Hermosa Street Improvements Project

Addendum/Clarification No. 2

PAVEMENT PATCHES

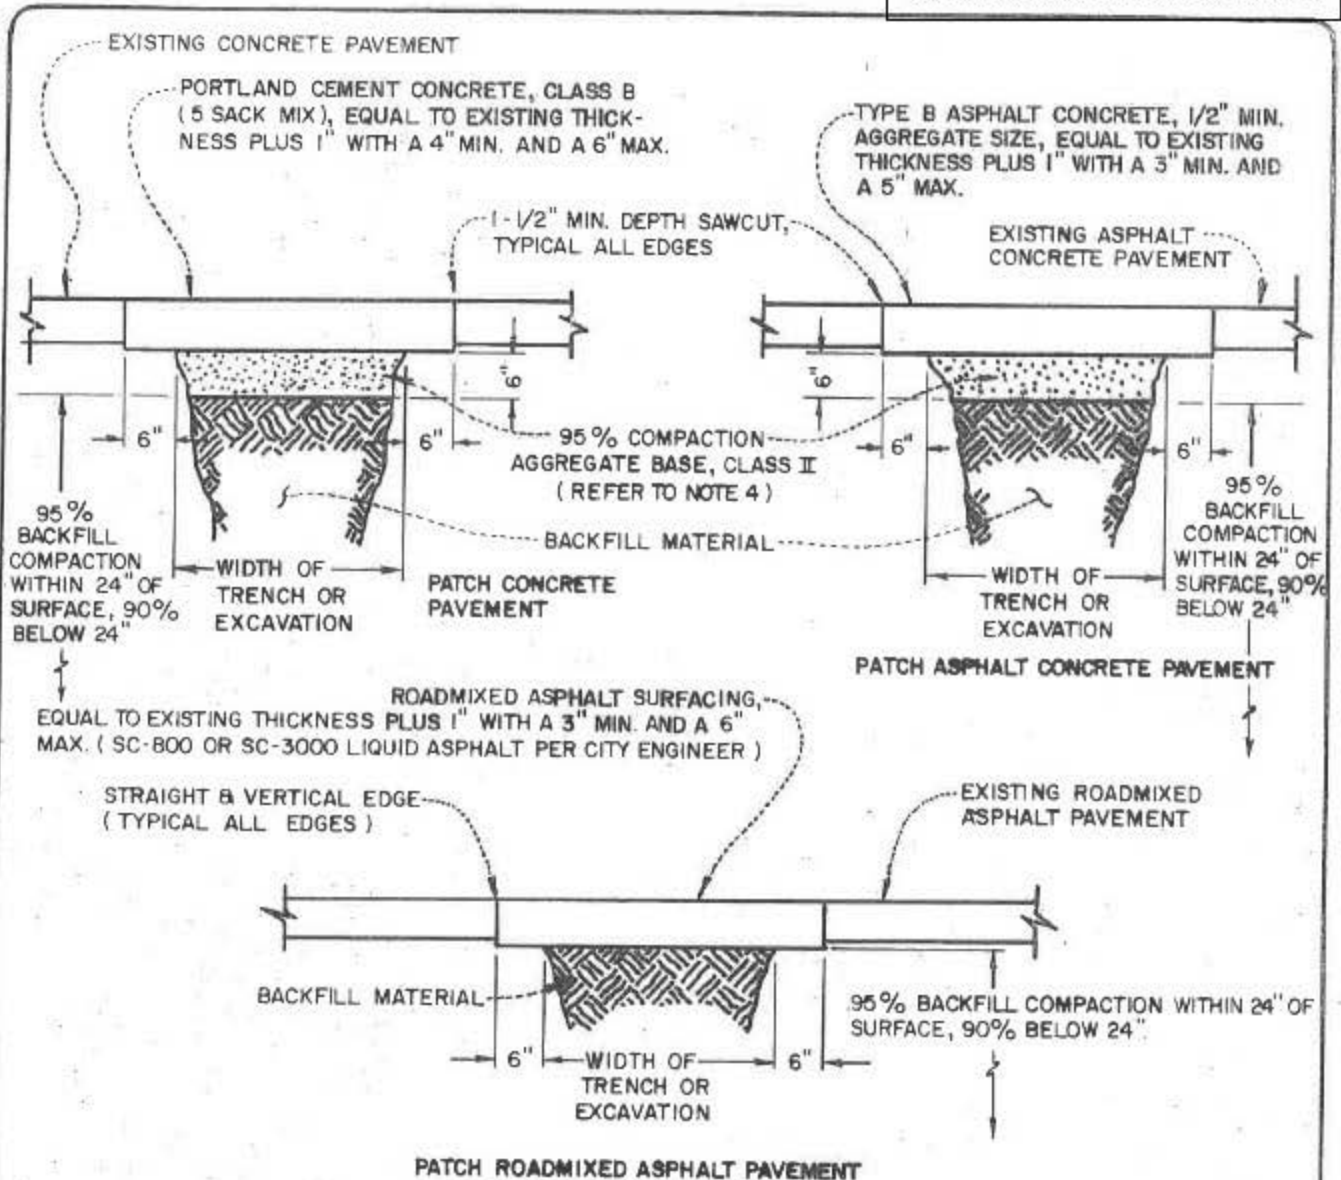
4. **Question:** Do you have a detail for the trench work?

Answer: See Sheet *ST-20: Pavement Patches* from the City's Development Standards on trench work (Attachment 2: Addendum No. 2). This information can also be found on the City of Lindsay's website (<https://www.lindsay.ca.us/>).
